Addendum No. 2
October 23, 2025

Project: Beresford High School Addition
Beresford, South Dakota
Project #2979

Architect: Architecture Incorporated

9 PLAN DETAIL - AREA A
4.40 SCALE: 1 1/2" = 1'-0"

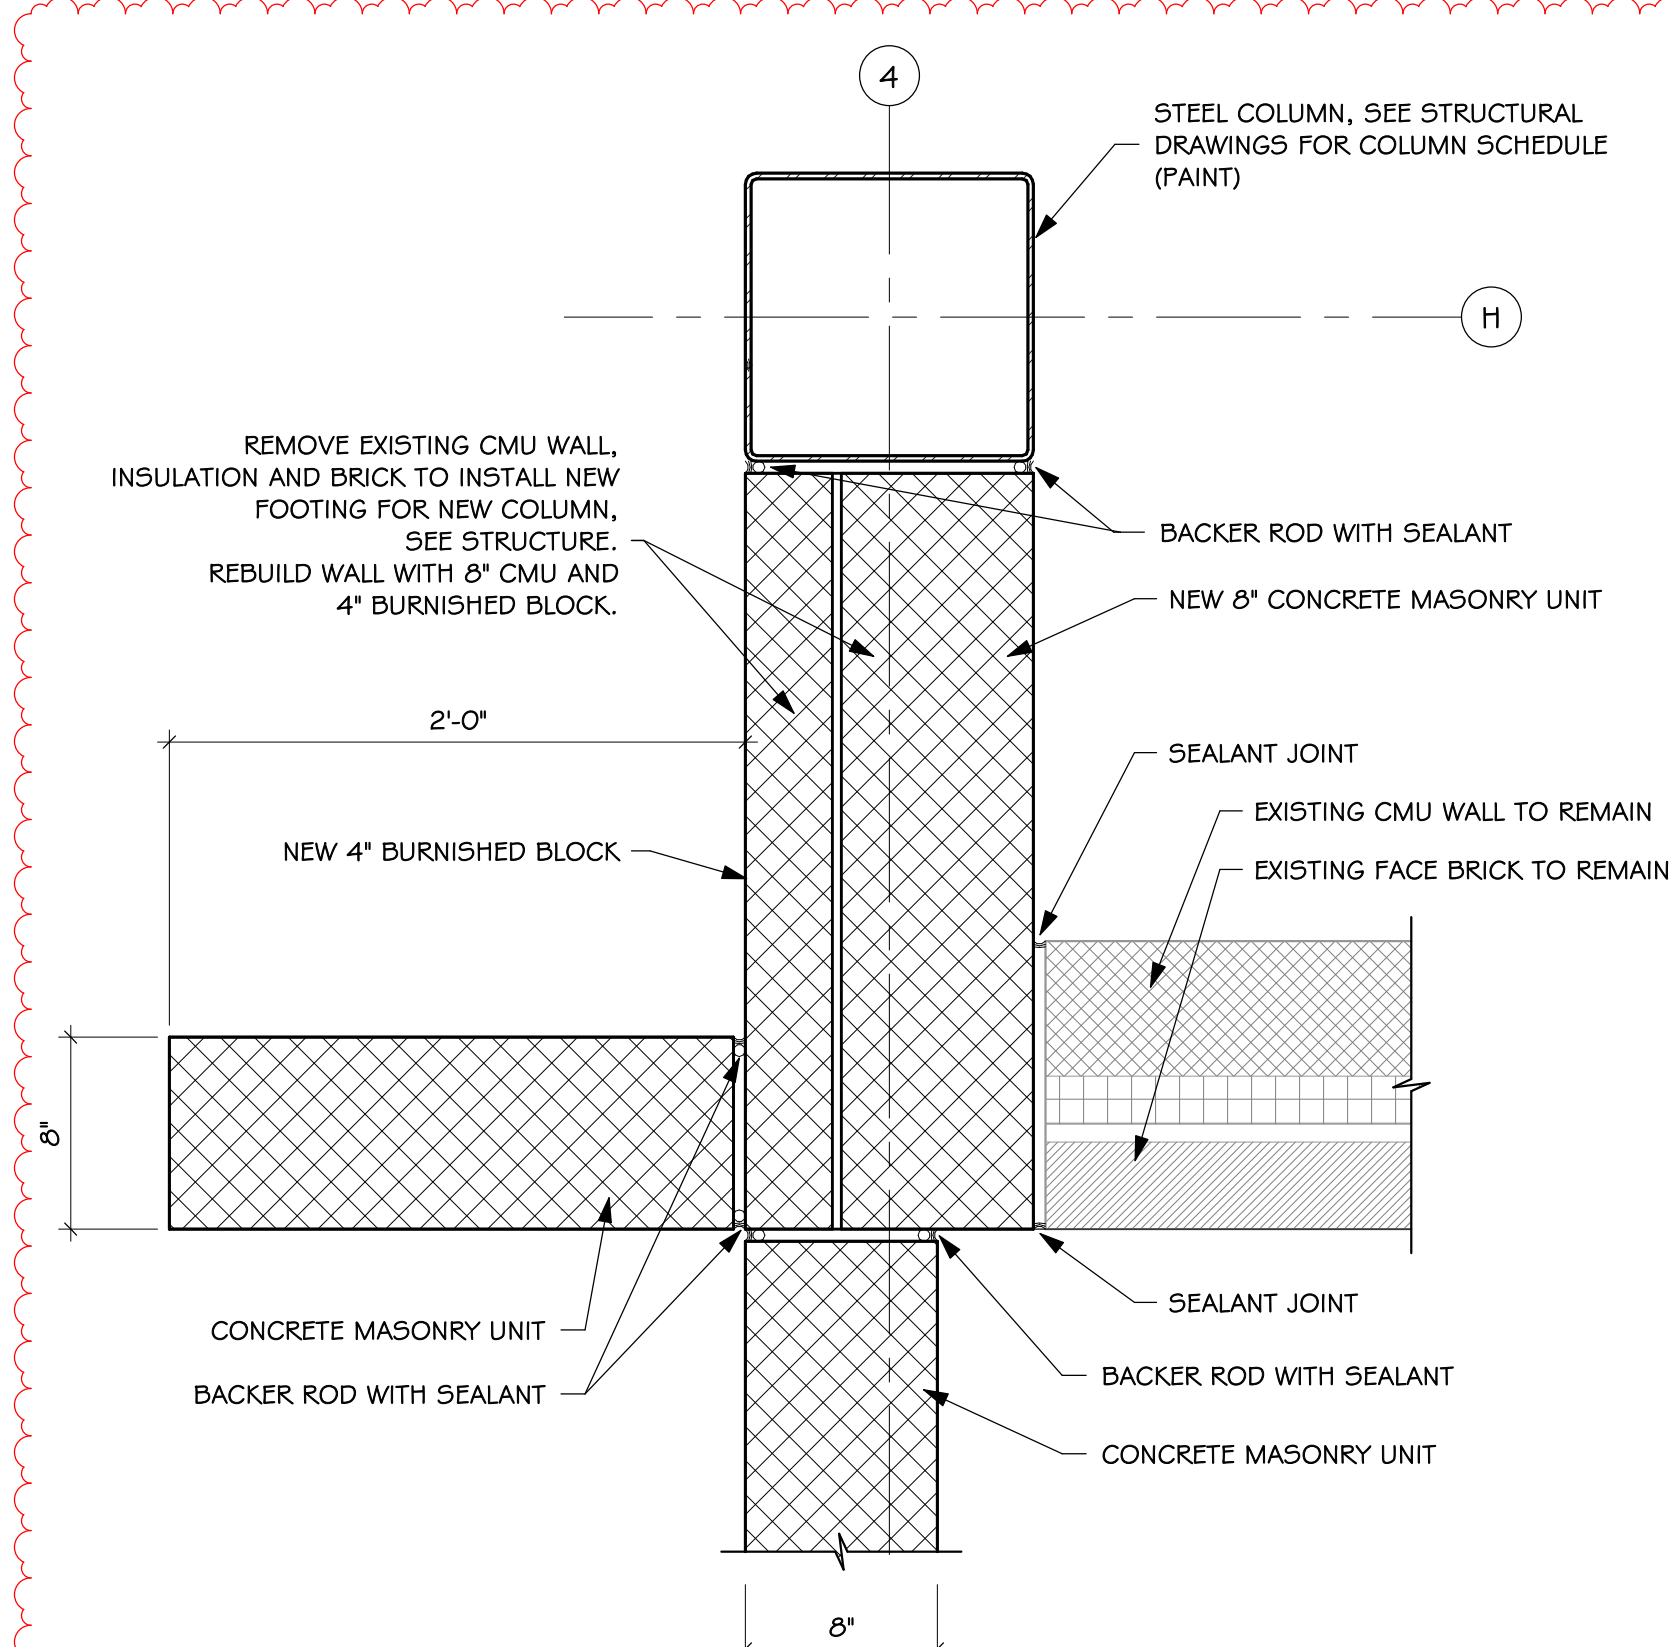
- a) Remove existing CMU wall, insulation and brick as necessary in order to install new footings for new steel columns at grid locations, F4, H4, F10 and H10; see structural drawings Sheet 3.20A and Sheet 3.20B.
 - i) Reference *revised* details 9 & 10 on *revised* Sheet 4.40 and *revised* details 2 & 3 on *revised* Sheet 4.41 – as noted elsewhere in this addendum.

- a) Refer to *revised* sheet 4.40, *revision* dated 10-23-2025, attached to the end of this addendum for following modifications.
 - i) Detail 8/4.40 & 9/4.40: Remove existing brick, insulation and concrete masonry wall as needed to install new footing for new steel column; refer to structural sheet 3.20A. Rebuild wall with 8" CMU and 4" burnished CMU as shown in revised details. Burnished CMU extends vertically to above ceiling and remainder of 4" CMU above ceiling is standard finish. Burnished CMU extends horizontally to Grid E as shown in *revised* detail 8/4.40.

10 PLAN DETAIL - AREA A
4.40 SCALE: 1 1/2" = 1'-0"

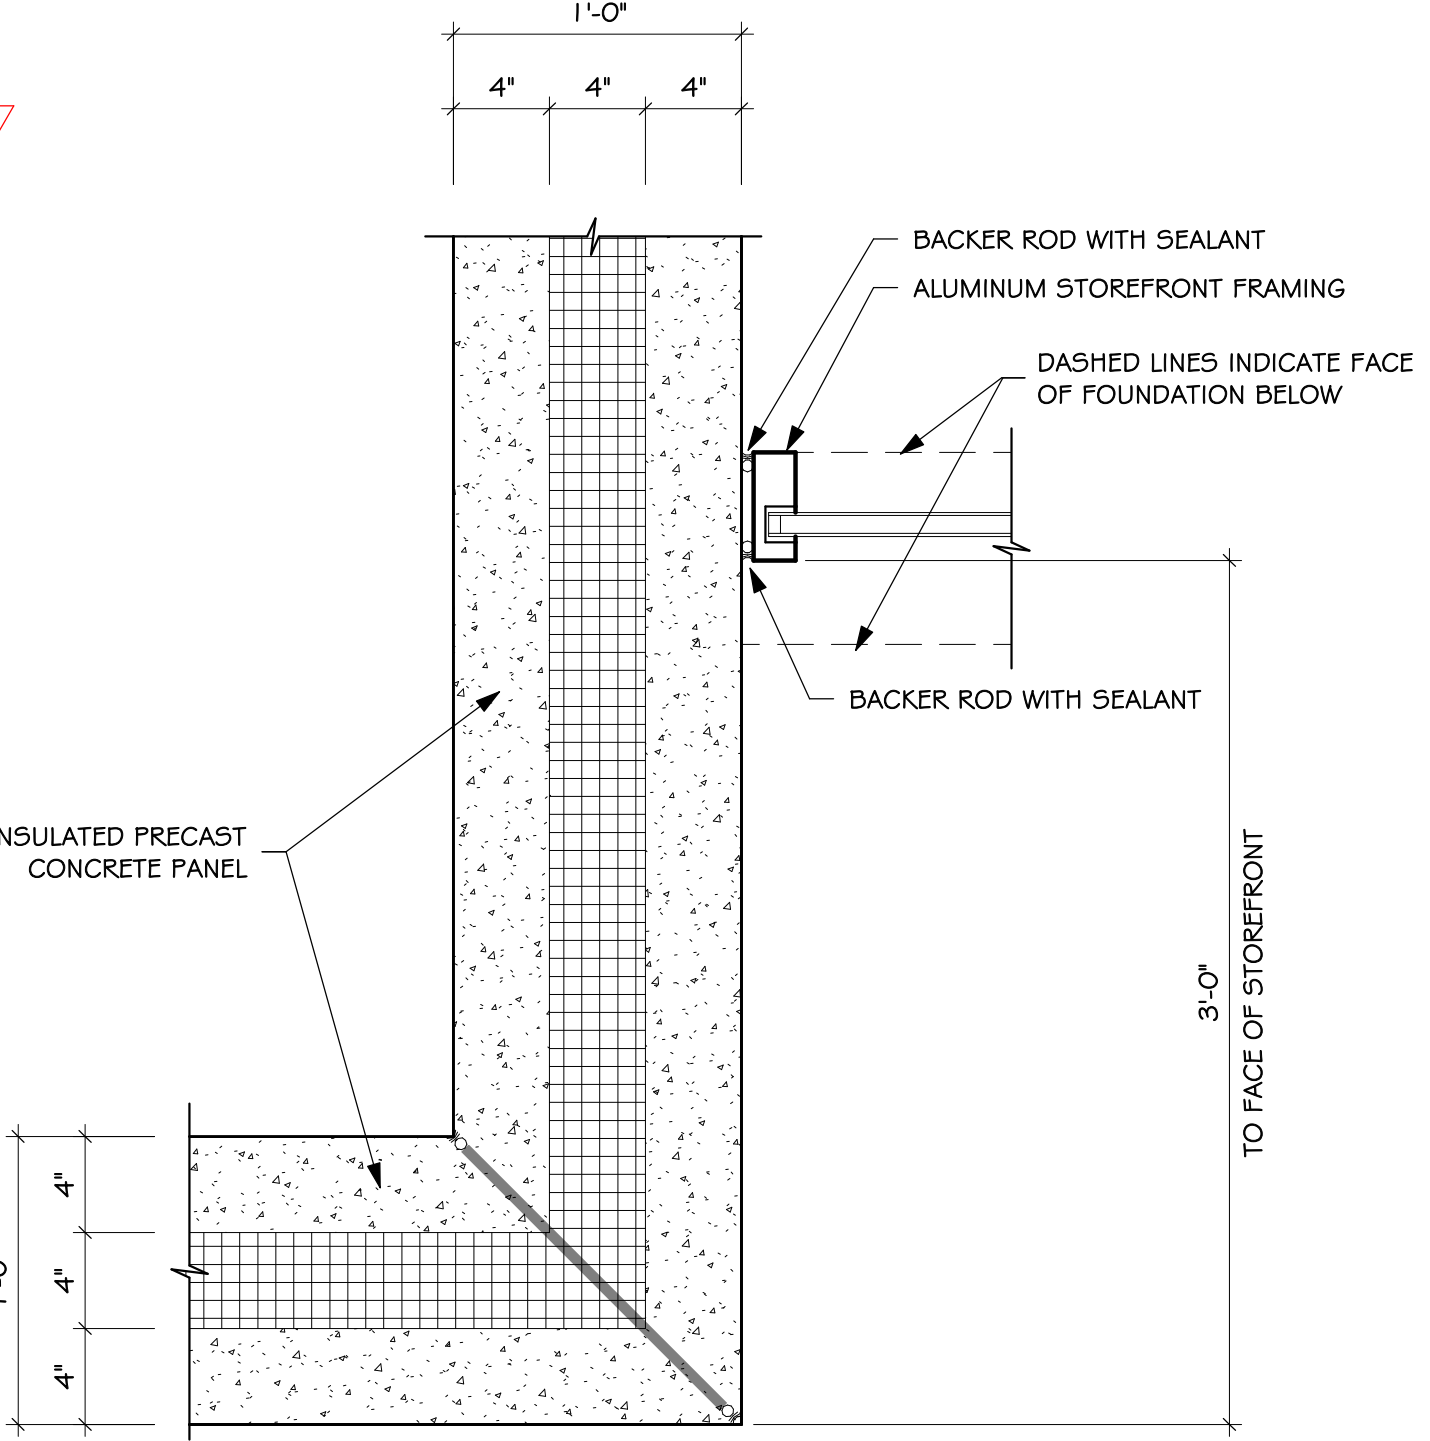
- ii) Details 10/4.40: Remove existing brick, insulation and concrete masonry wall as needed to install new footing for new steel column; refer to structural sheet 3.20A. Rebuild wall with 8" CMU and 4" burnished CMU as shown in revised details. Burnished CMU extends vertically to above ceiling and remainder of 4" CMU above ceiling is standard finish.

2 PLAN DETAIL - AREA B
4.41 SCALE: 1 1/2" = 1'-0"

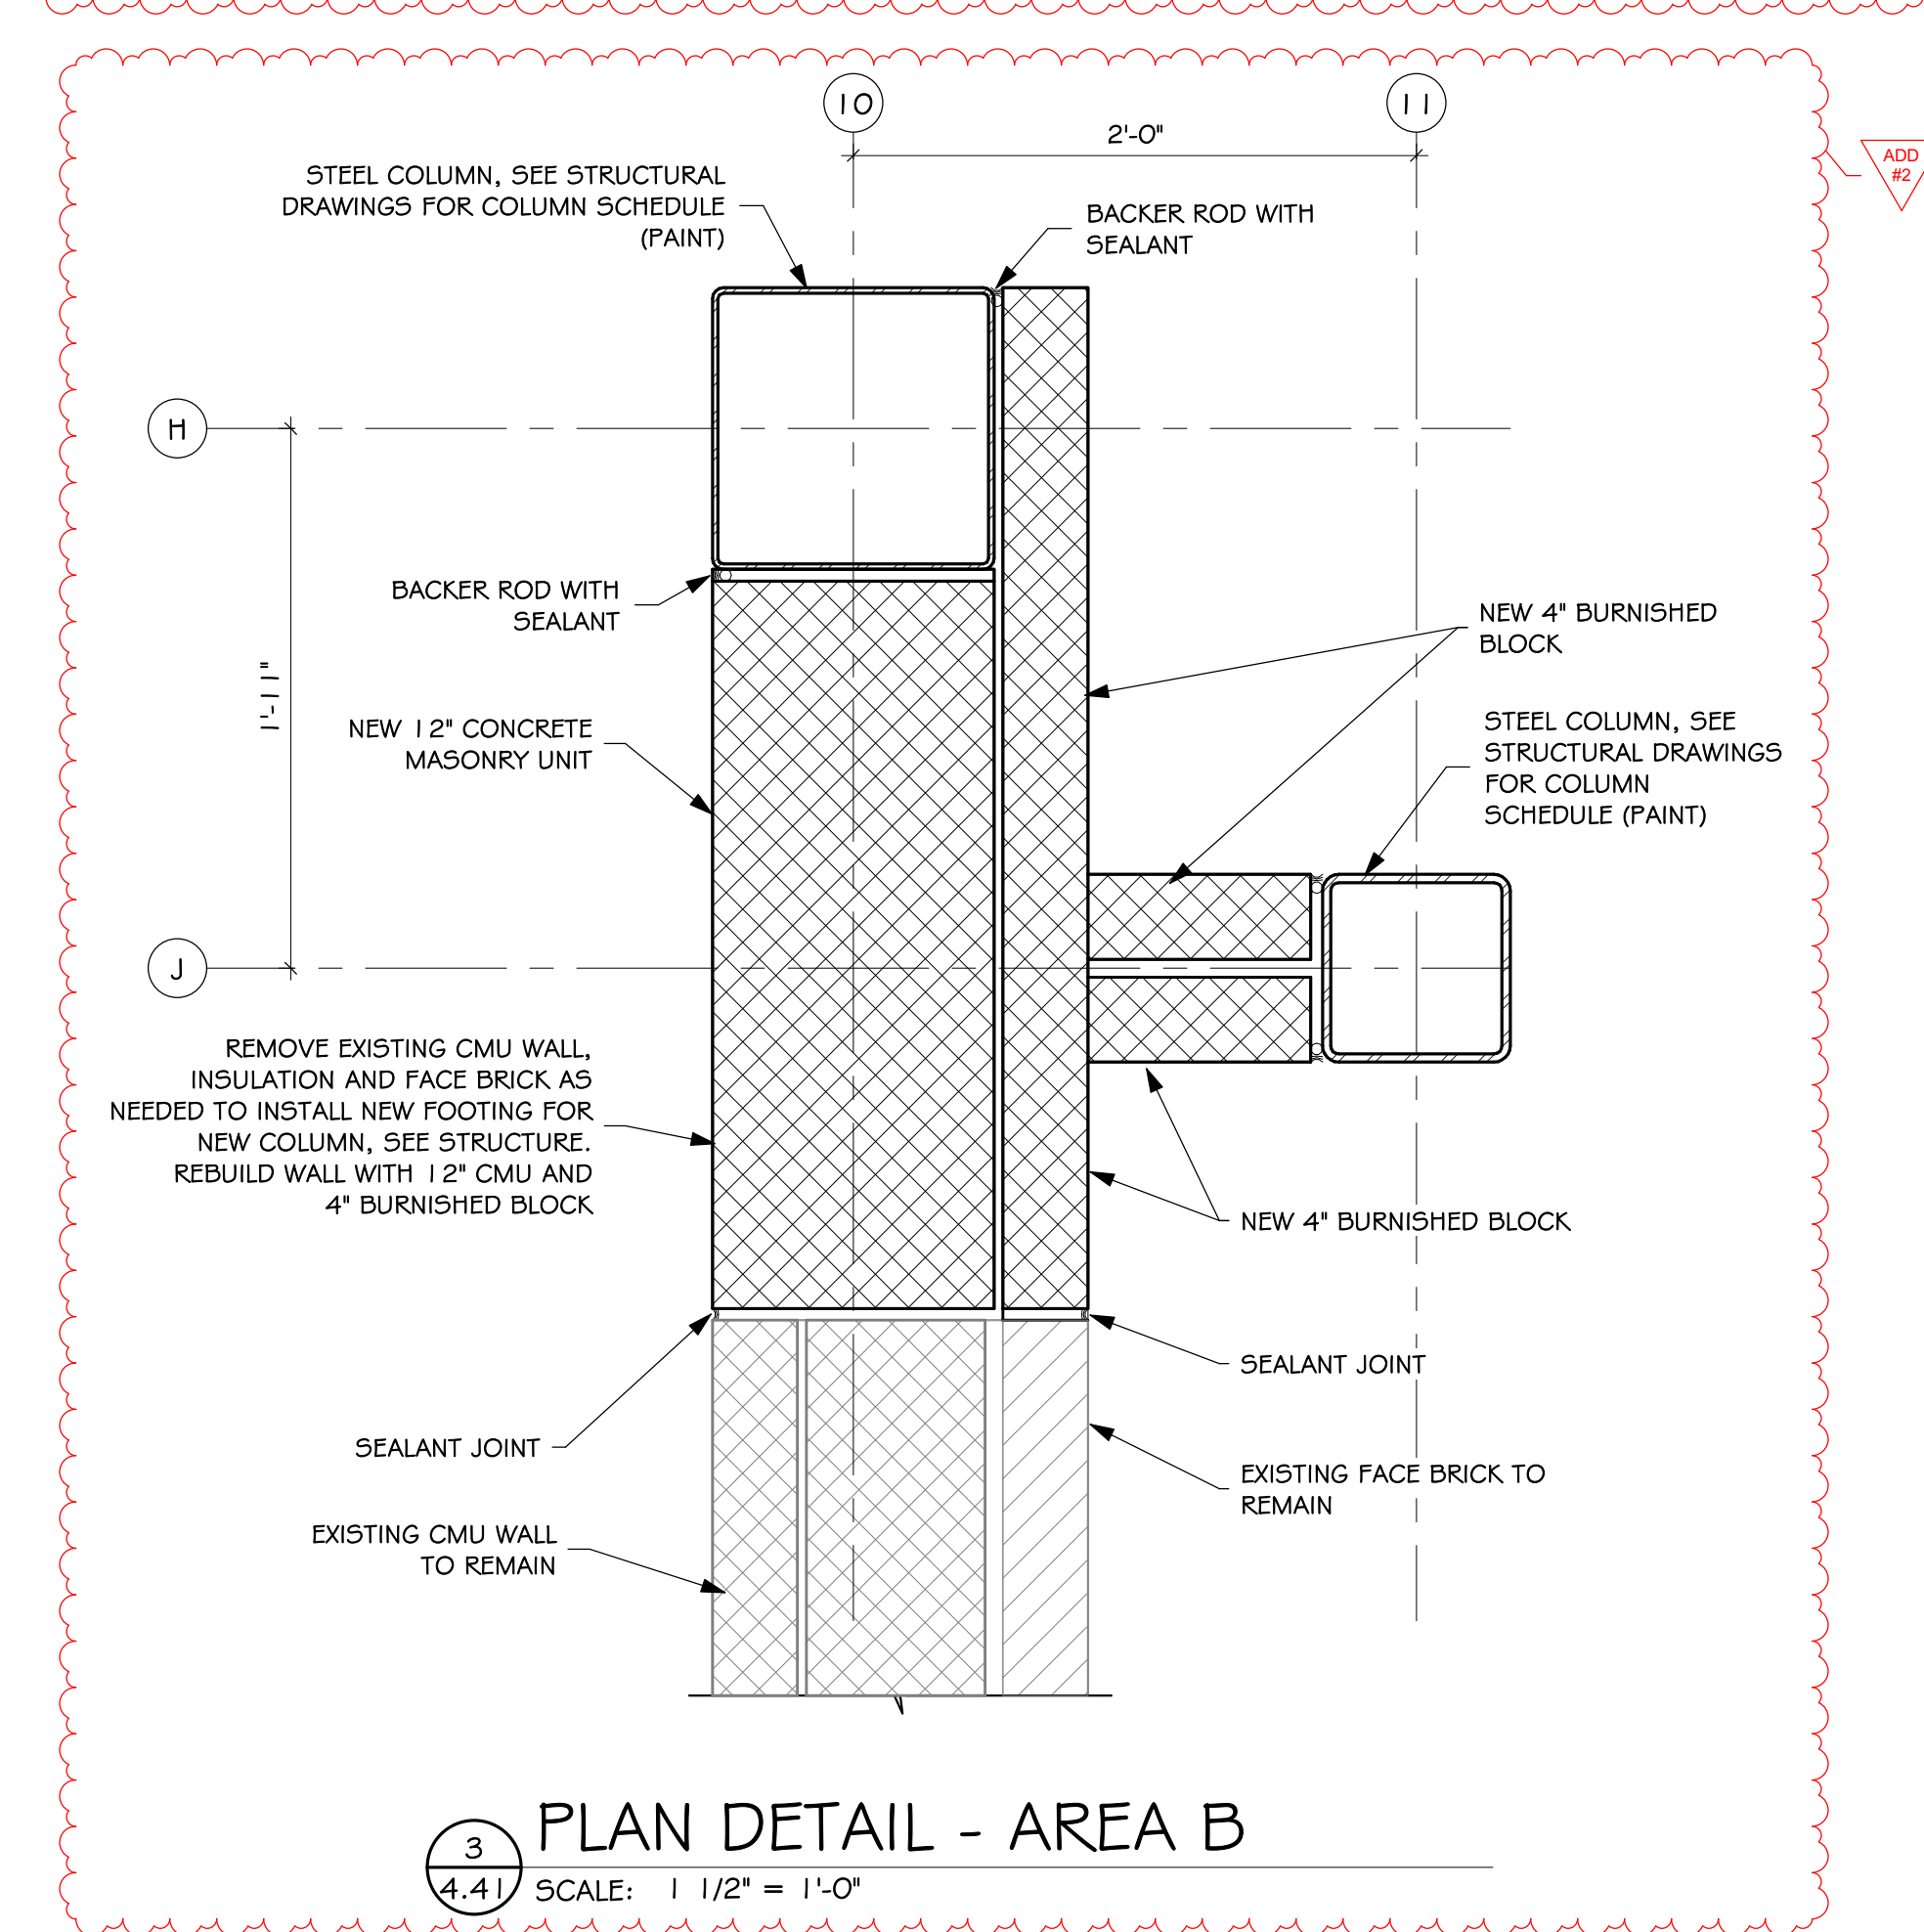
- a) Refer to *revised* sheet 4.41, *revision* dated 10-23-2025 attached to the end of this addendum for following modifications.
 - i) Detail 2/4.41: Remove existing brick, insulation and concrete masonry wall as needed to install new footing for new steel column; refer to structural sheet 3.20B. Rebuild wall with 8" CMU and 4" burnished CMU as shown in revised detail. Burnished CMU extends vertically to the bottom of steel stud wall and remainder of 4" CMU above is standard finish.
 - ii) Detail 3/4.41: Remove existing brick, insulation and concrete masonry wall as needed to install new footing for new steel column; refer to structural sheet 3.20B. Rebuild wall with 12" CMU and 4" burnished CMU; 4" burnished CMU to be flush with face of the existing brick as shown in revised detail.
